**Subject:** Preliminary Questions in Chapter 2 of the STP COLA

The following table represents a draft list of discussion items that will be discussed during the safety site audit for the STP Units 3 & 4 COLA FSAR Chapter 2. Additional items or changes may be added to the existing list, based on discussion and review.

**Preliminary Information Needs for the STP Safety Site Audit**

**Figure 1**  
**STP Stability Class Frequency Distributions**

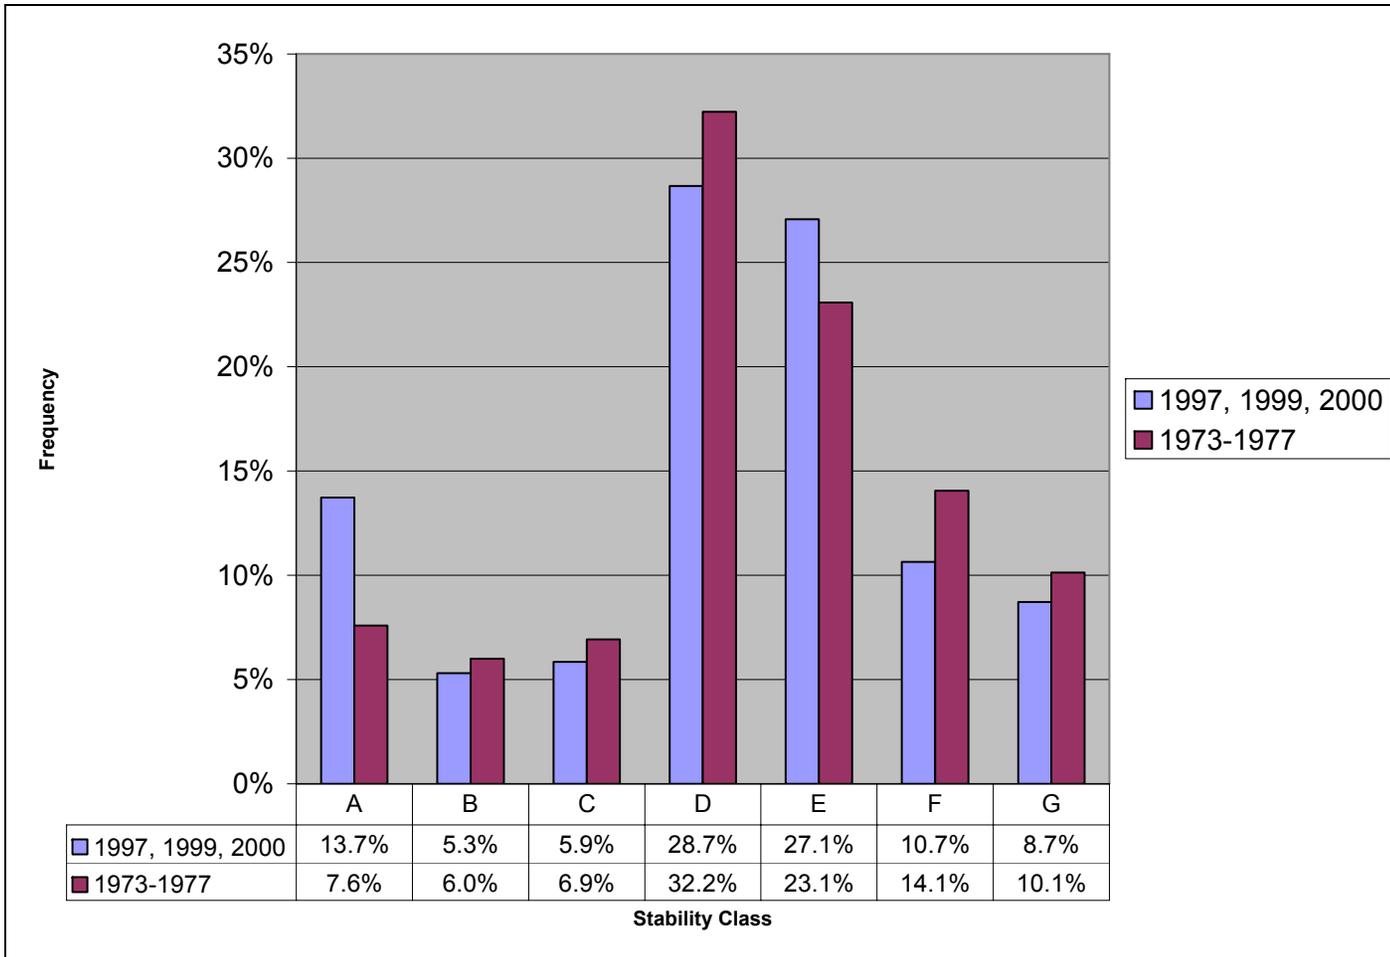
23.	2.3S3.4.1.2	Meteorology	Please explain the 6% increase of onsite A stability class frequency from the original data set (1973-1977) to the current (1997, 1999, and 2000) data set as shown in FSAR Table 2.3S-20 (see Figure 1).	Brad Harvey
